MM11

FIELD SERVICE TECHNICAL MANUAL				Option or Designator
	12 Bit <input type="checkbox"/>	16 Bit <input checked="" type="checkbox"/>	18 Bit <input type="checkbox"/>	36 Bit <input type="checkbox"/>	MM11

Engineering Change Order Log

FIGURE 1

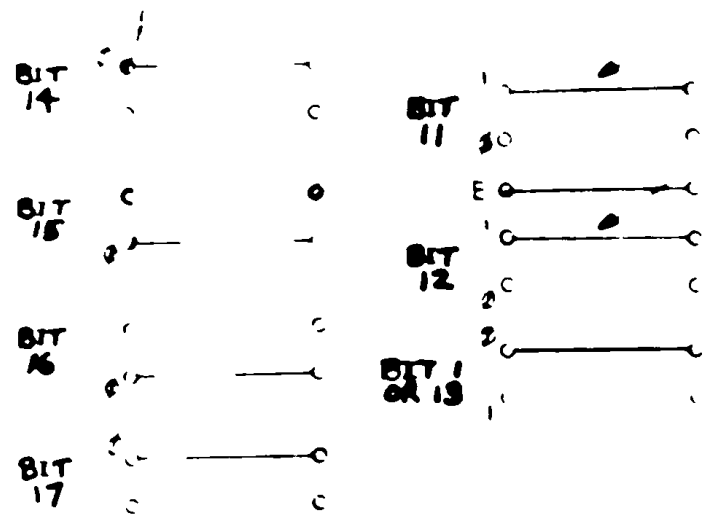
Both the MM11-E and MM11-F memories now utilize M1091 address selector modules. Figure 2 shows the circuit schematic of the M1091 address selection logic. Figure 1 shows a layout of that portion of the physical module where the addressing is accomplished by insertion or removal of jumper wires. Table 1 lists the following

- d. Bits 17, 16, 15, 14, 13 and 01 Non-Interleaved - These columns show, by an X, that jumper which should be installed in order to respond to a specific memory bank addressing. The 1, 0, A, B, C and D correspond to the identification shown on the module, figure 1, and figure 2.

MUST BE REMOVED BEFORE INSTALLATION IN AN MM E OR F

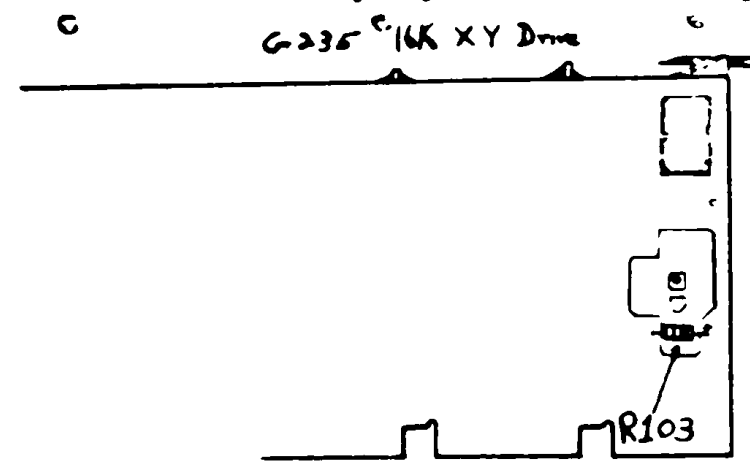
Many reports have been received from the field concerning memories failing high current margins and module set incompatibility (i.e. unable to swap modules). Investigation has shown that the inhibit margins are not properly centered, which could cause marginal operation of the memory under conditions of high drive currents. An ECO (G235-0009) was generated to correct this problem.

Therefore, if a memory exhibits these symptoms, do a visual inspection of the G235 for the ECO. A quick check for the ECO is:

1. Place G235 component side up and fingers toward you.
2. Look at right hand side of module in large etch area (see drawing).
3. If resistor R103 (750 1W) which is across bottom of large etch is not in, ECO has not been installed.

This ECO should be installed before attempting massive module swap or option swap.

ECO # MM11E-00015

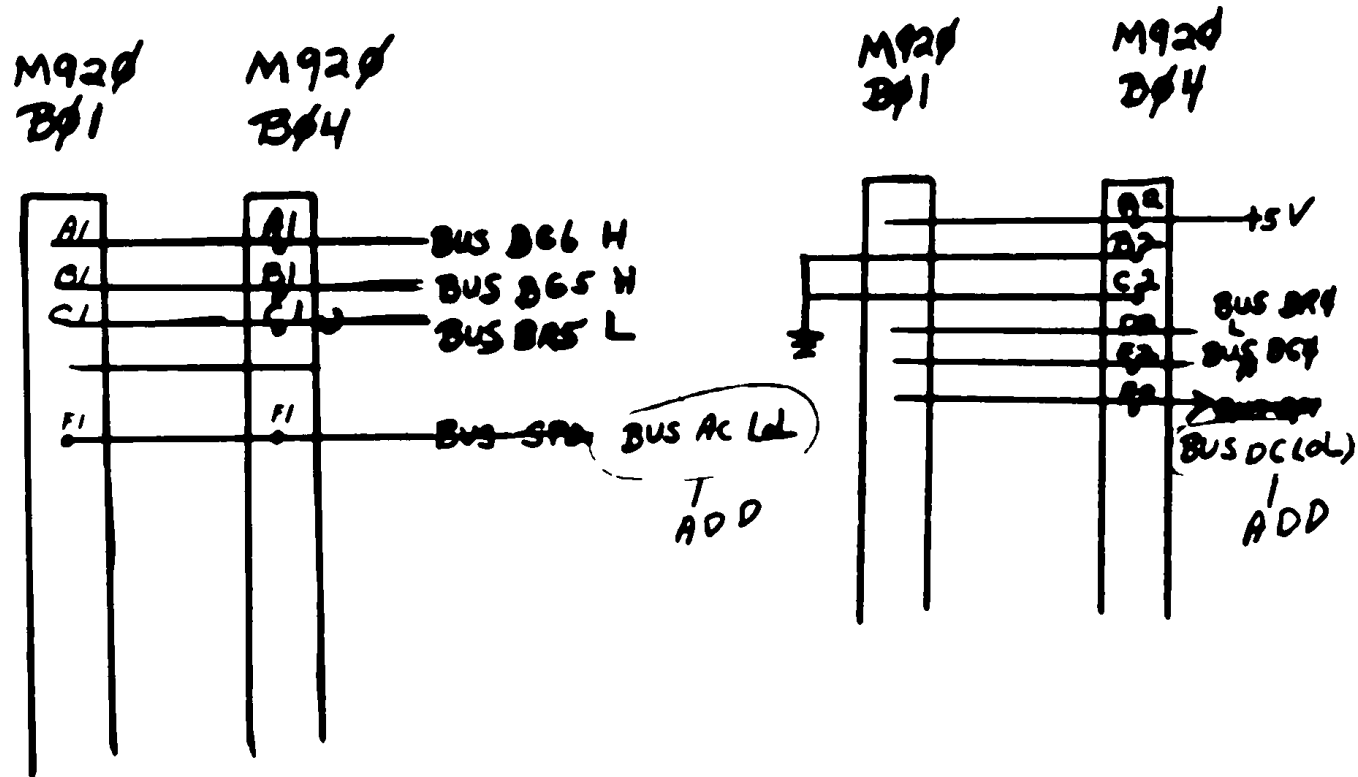
1. INSTALL WIRES.
2. CORRECT PRINTS.
3. NOTE: IF INSTALLATION OF THIS UNIT CREATES A MULTIPLE BOX SYSTEM, THIS ECO AND ECO NUMBER 5408475-00006; ECO NUMBER M930-00001 MUST BE INSTALLED. ONE SET OF CONNECTIONS BETWEEN THE POWER BUS AND UNIBUS ARE REQUIRED FOR EACH BALL WITHIN A SYSTEM.

ECO# MM11E-00016 D-AD-7006468-0-0

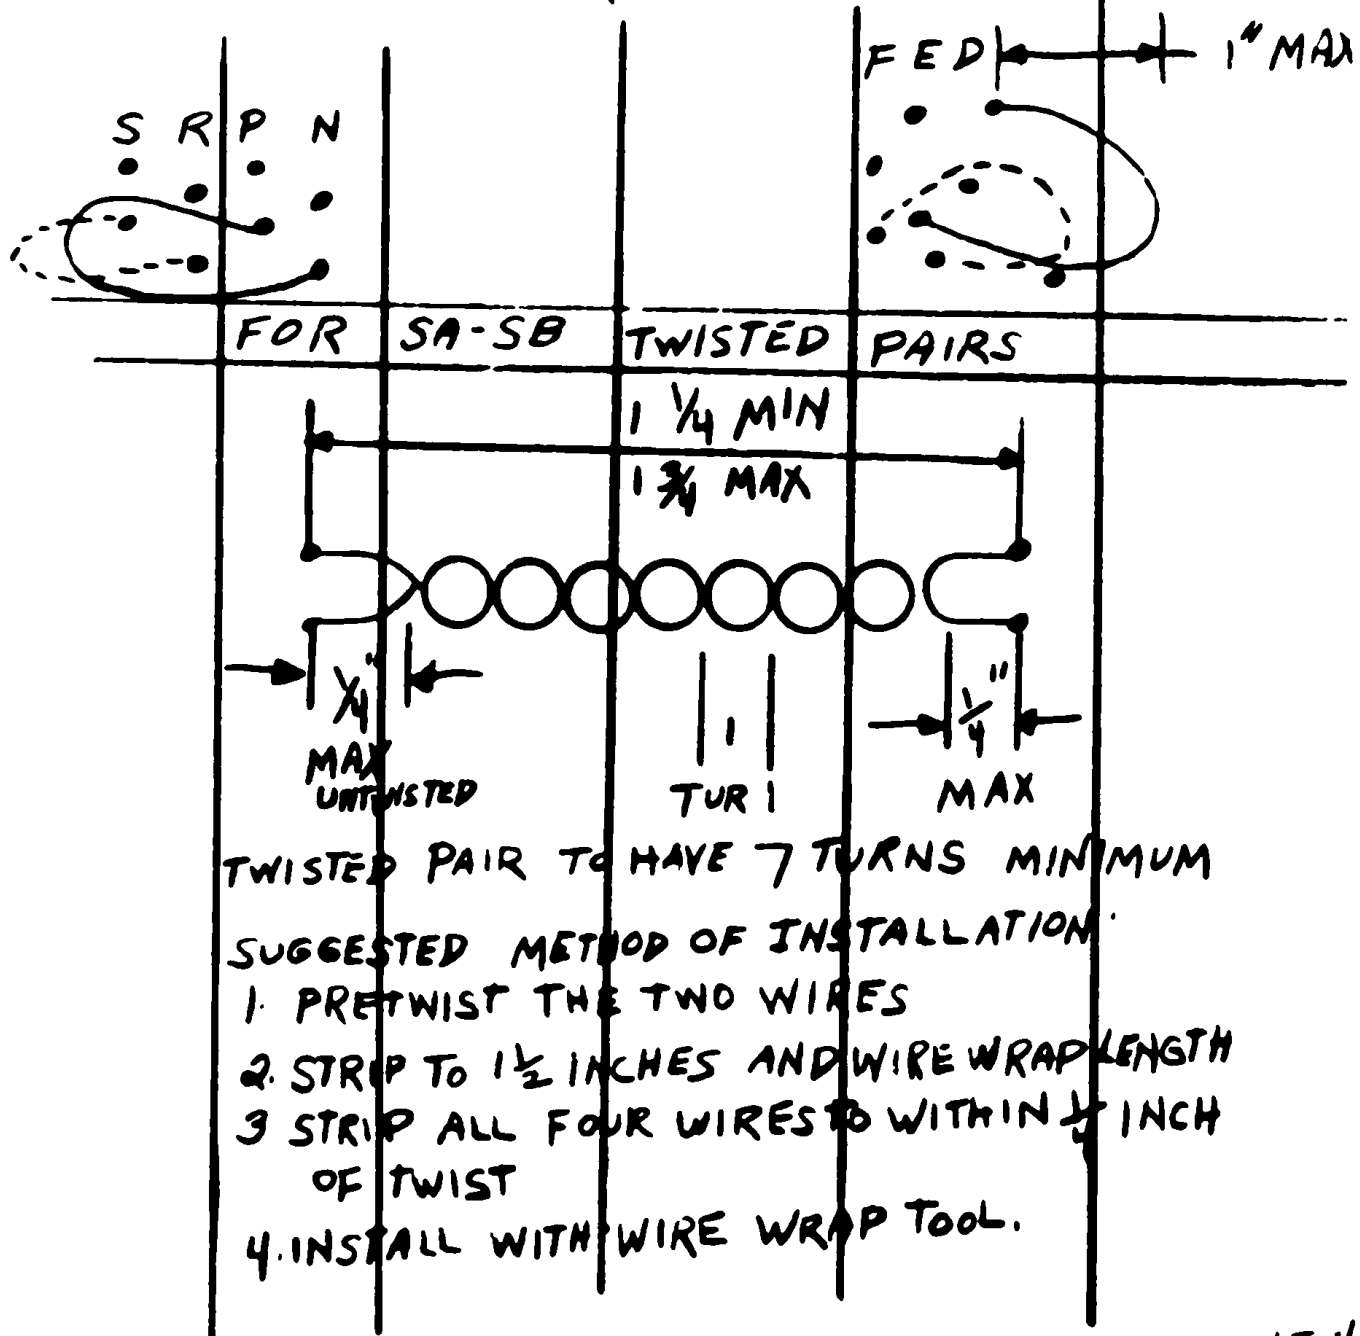
LENGTH SHOULD BE A MAXIMUM OF
 $2\frac{1}{4}$ INCHES. CHECK DRAWING FOR
 LENGTH AND FOR HOW LOOPS SHOULD
 BE DRESSED INTO LOGIC.

ECO* MM1E-00017

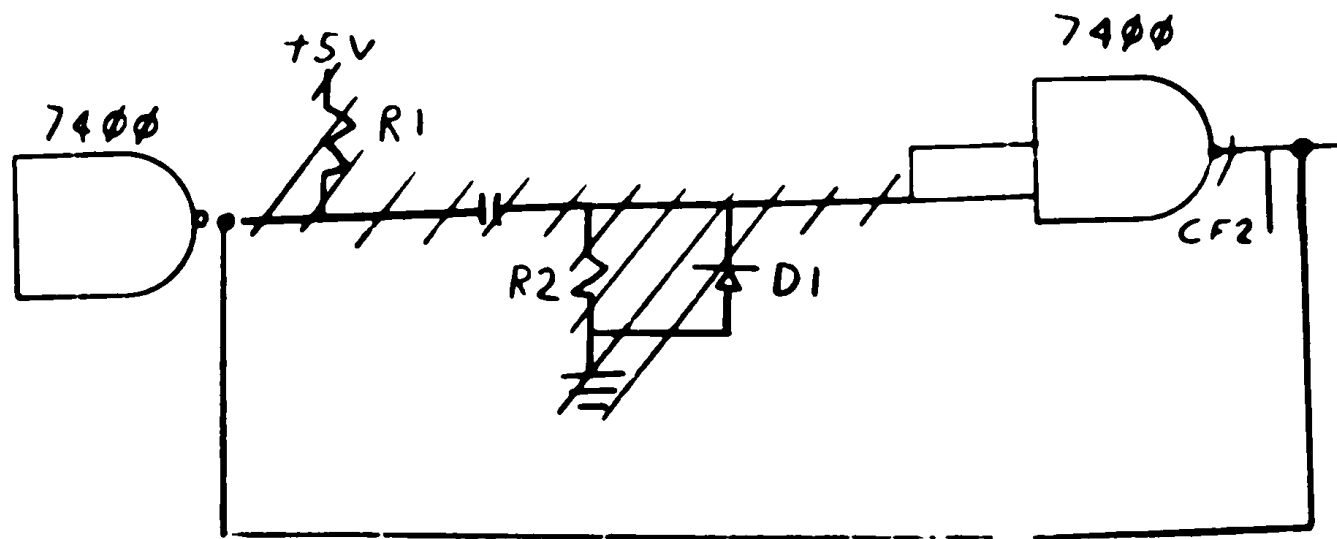
SIGNAL NAME	FROM PIN	TO PIN	COMPONENTS	ADD	DEL
<i>BUS AC LO L</i>	<i>B04E1</i>	<i>A03R2</i>		<i>X</i>	
<i>BUS AC LO L</i>	<i>B04E2</i>	<i>A03S2</i>		<i>X</i>

ECO NO MM11E-0002Y

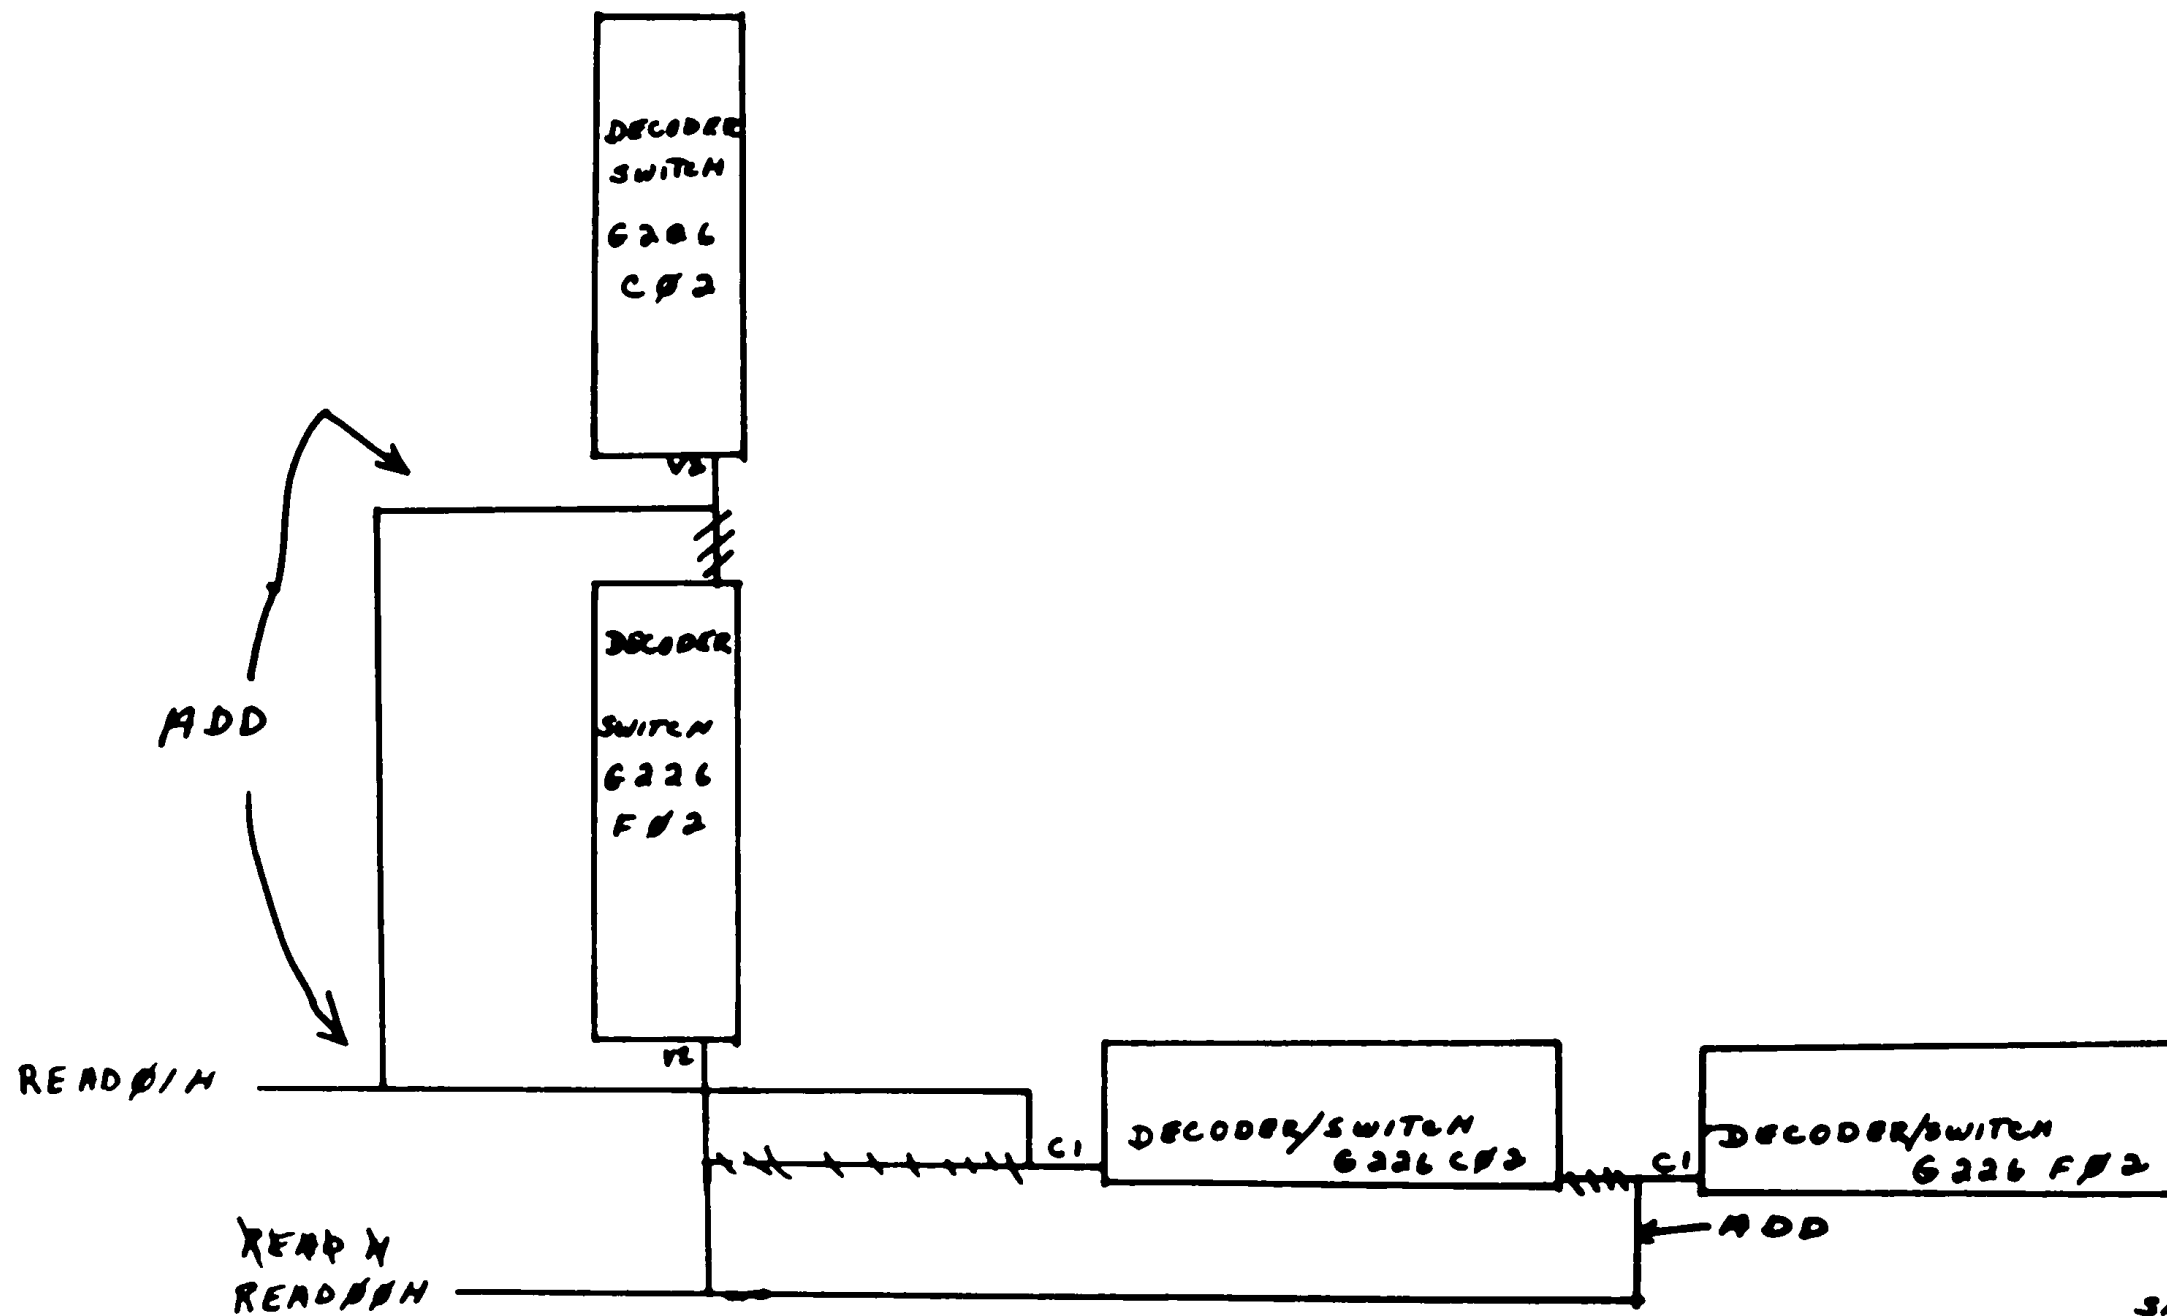
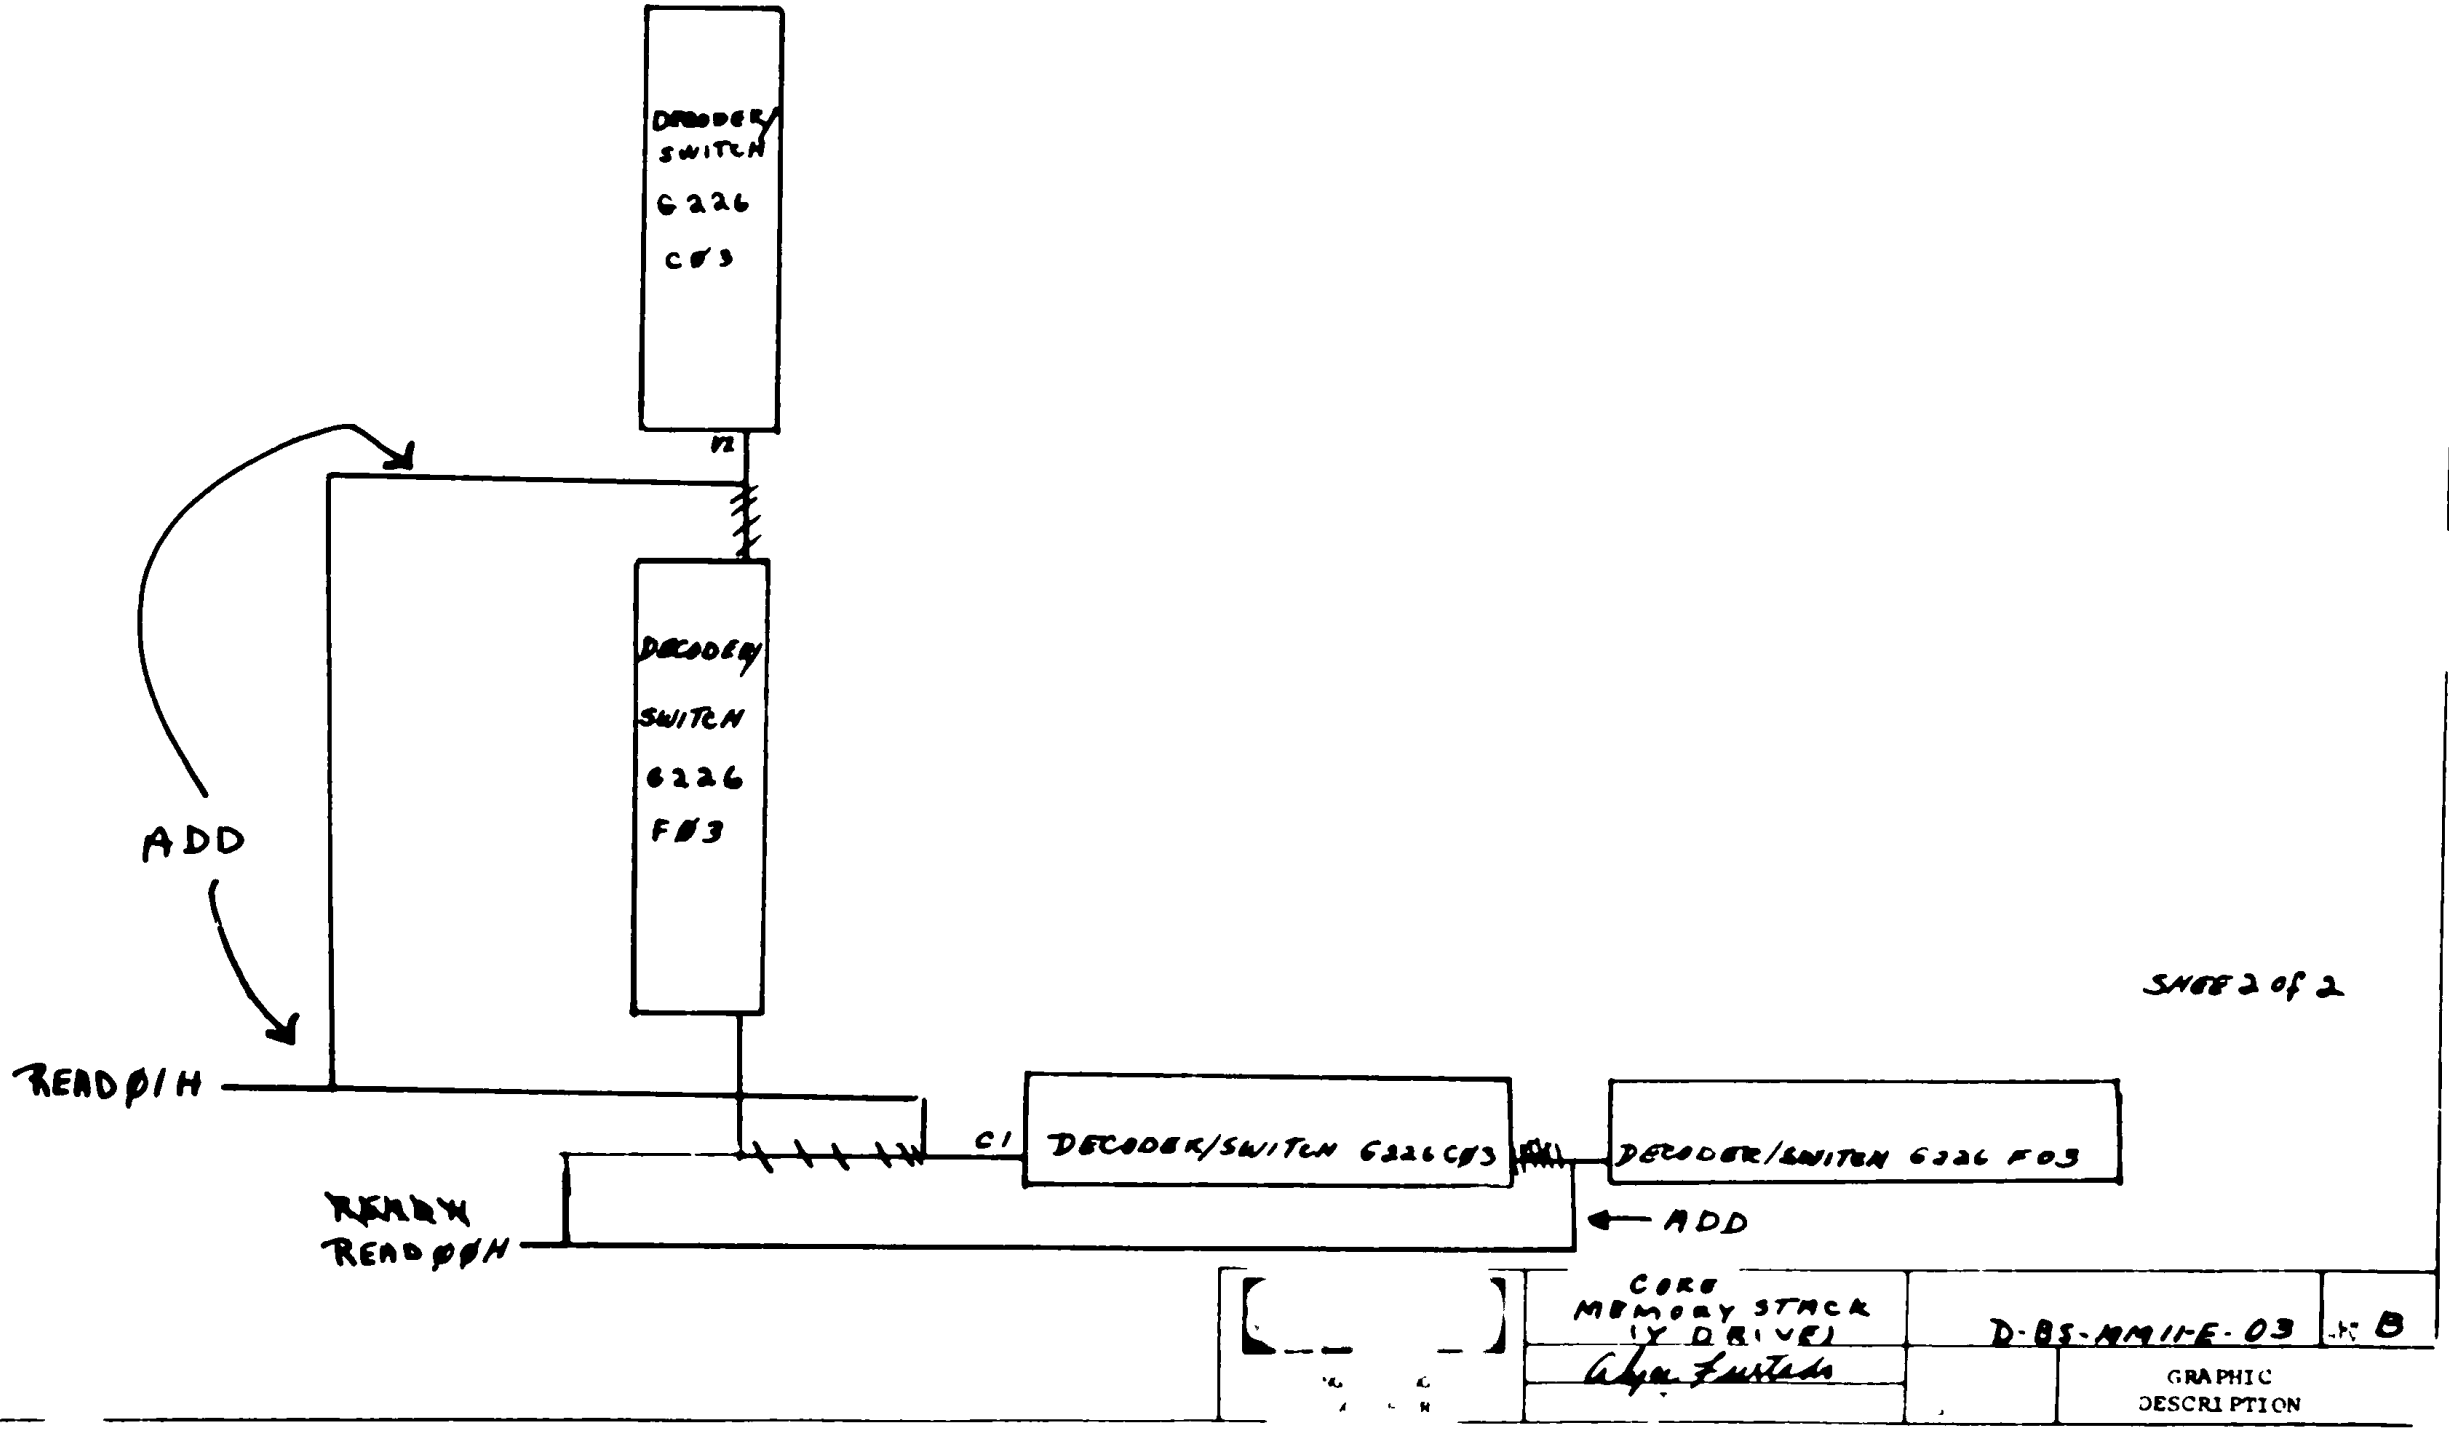
SIGNAL NAME	FROM PIN	TO PIN	COMPONENTS	ADD	DEL
READ H	C02V2	D01A1	REMARKS		X
READ 01 H	C01F2	C02C1		X	
STROBE 00 H	C01F1	D02S1			X
STROBE 01 H	C01A1	E02S1			X
TINH 0 H	D02E1	E01S1			X
TINH 1 H	E01H2	F01F1			X
STROBE 00 H	C01F1	D02S1	WHT		X
GND	C01C2	D02T1	BLK	TWP	X
STROBE 01 H	C01A1	E02S1	WHT		X
GND	C01C2	E03T1	BLK	TWP	X
T 0 1 H	E01S1	D02E1	WHT		X
GND	E01C2	D01C2	BLK	TWP	X
T 1 1 H	E01H2	F01E1	WHT		X
GND	E01C2	F01C2	BLK	TWP	X
